CONDITIONS OF APPROVAL:

Engineering - Site Plan Checklist

Water's Edge Development Plan Rev. 4 11.3.2016.pdf

2. K. Overall Utility Plan

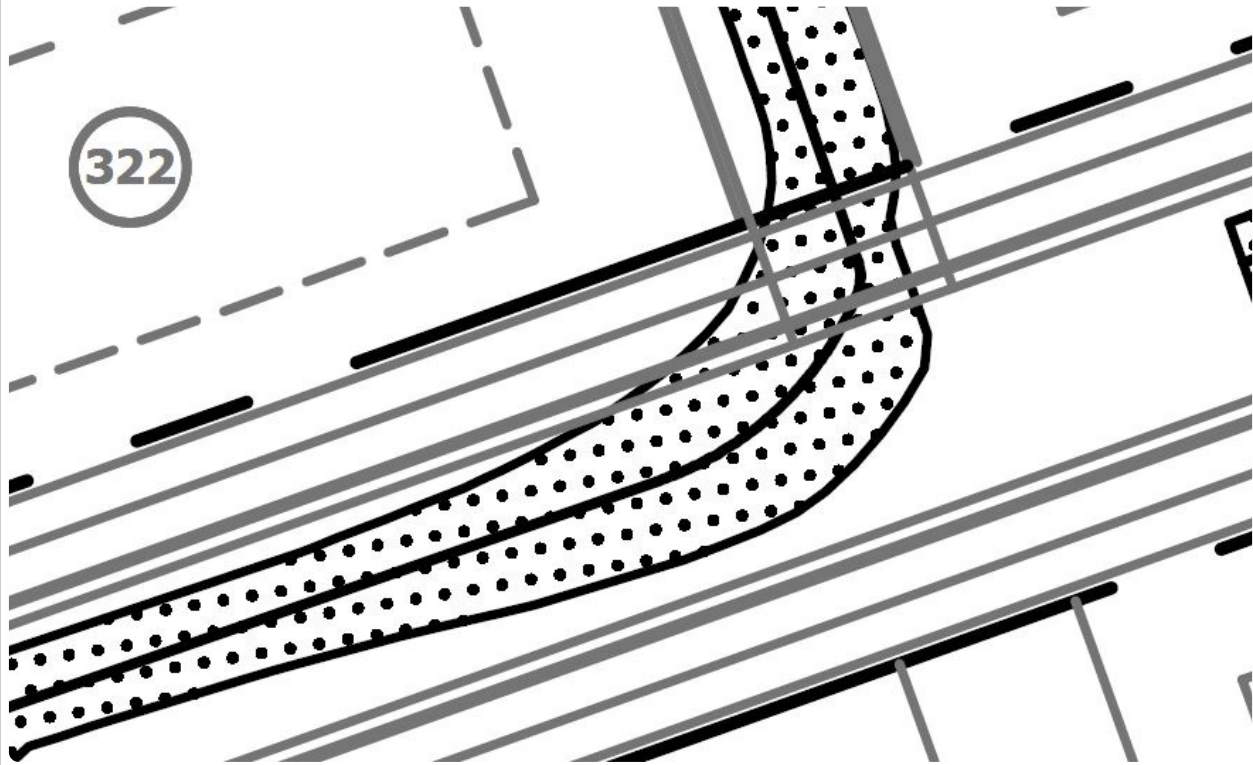
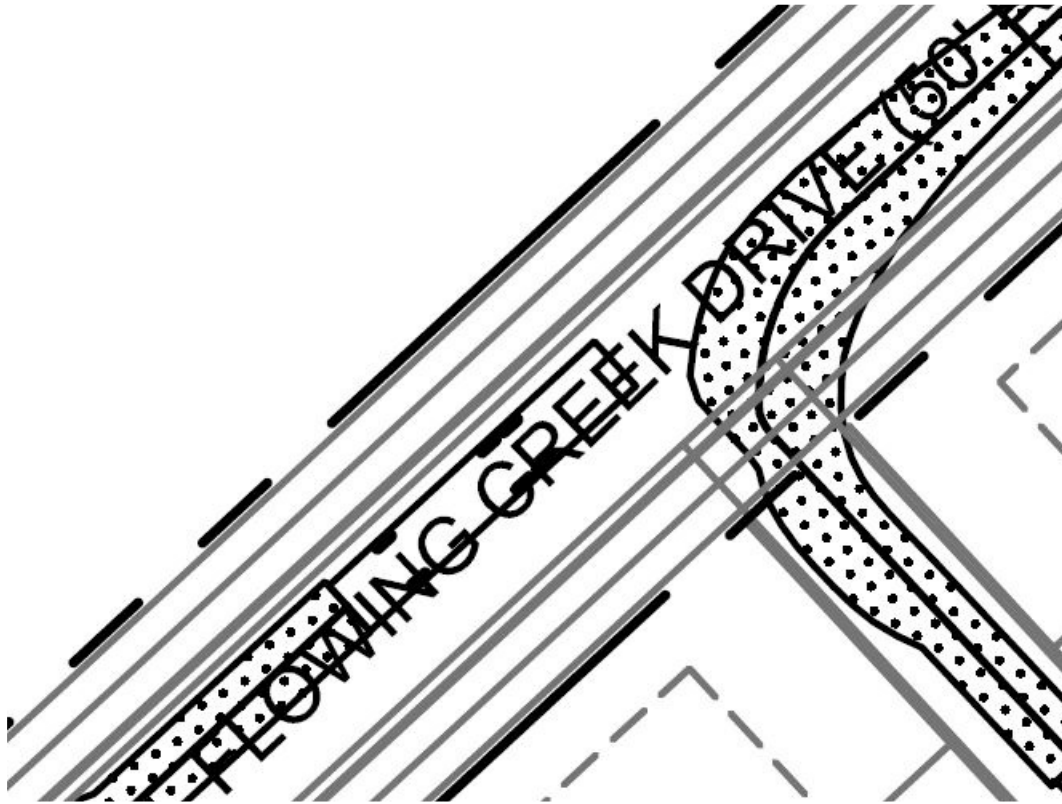
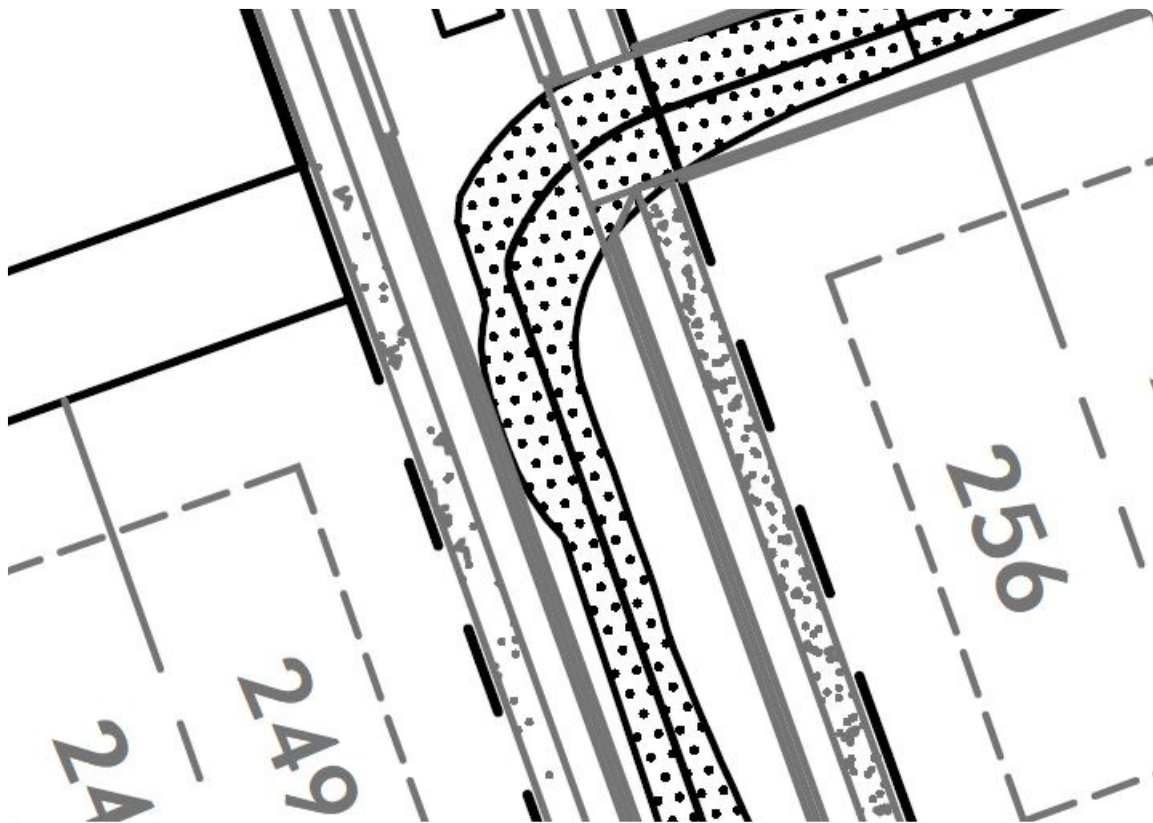
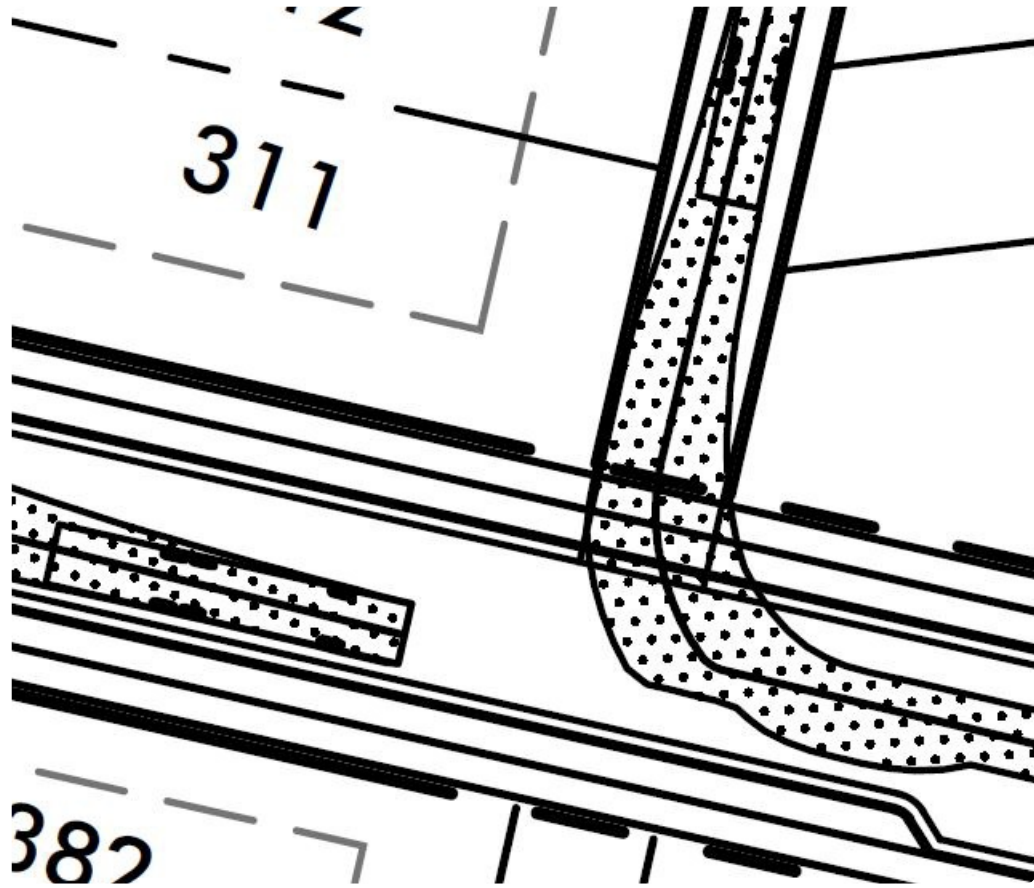
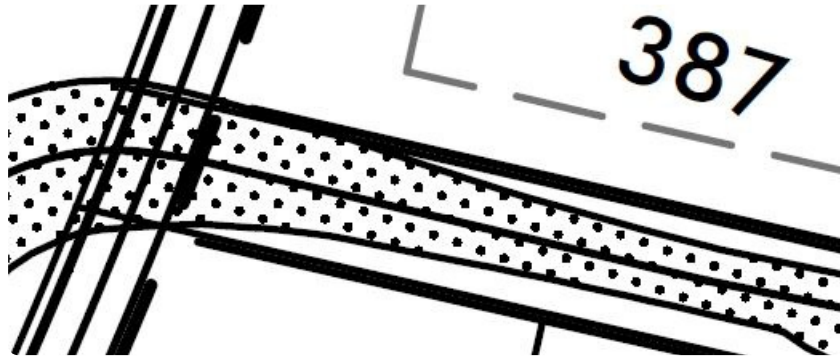
These issues to remain open to be addressed at Site Plan, but do not hinder Development Plan approval:

- Applicant shall be aware that no trees will be allowed to be planted within the sewer easement crossing the Open Space lot, and a note stating that the City is not responsible for any other plantings within the easement that are damaged or removed in the course of maintenance will be required on the plat.
- Applicant shall verify with Milcrofton utility that the proposed location of their water line adjacent to the alley(s) in the rear of the units where it will be overlain with driveways, mailboxes, etc is acceptable.

3. D. Site Plan

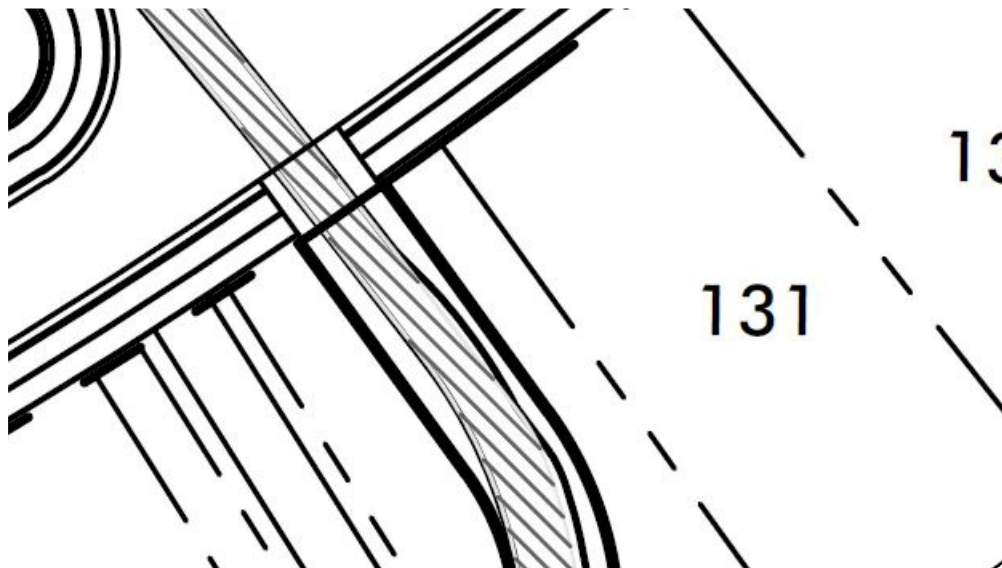
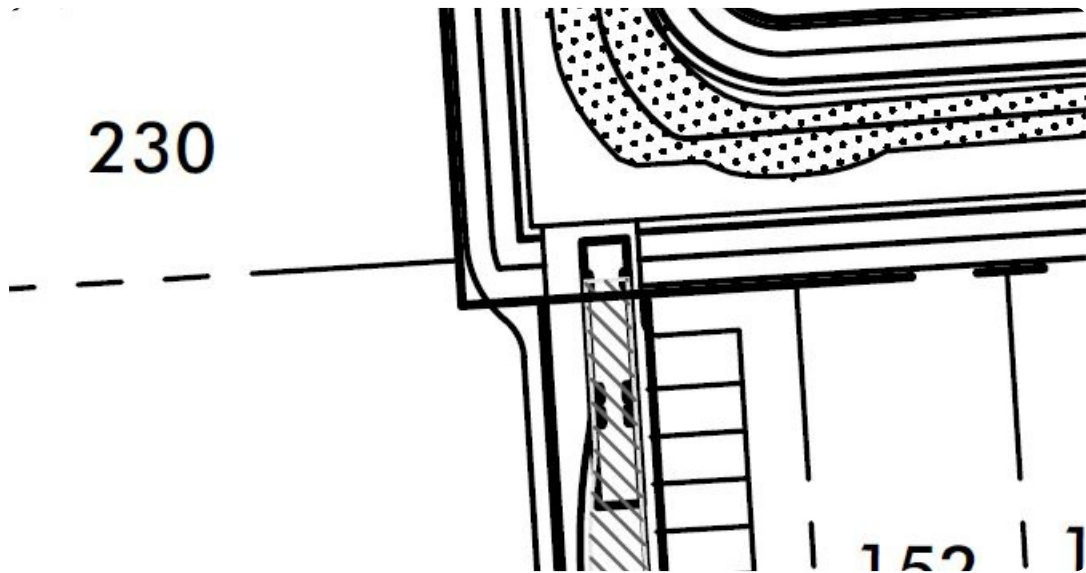
The previous comment, "Note that the proposed alley(s) with 90-degree, squared-off intersections with the street do not appear to have sufficient radius to allow the necessary turning movements" remains an issue, with the provided autoturn exhibit showing fire apparatus driving over curbs, sidewalks, etc.

Turning movements for these intersections not addressed:

These shall be addressed at Site Plan with widened alley throats, larger radius returns for alley intersections, or other layout adjustments as necessary to facilitate alley access for fire apparatus and service vehicles.
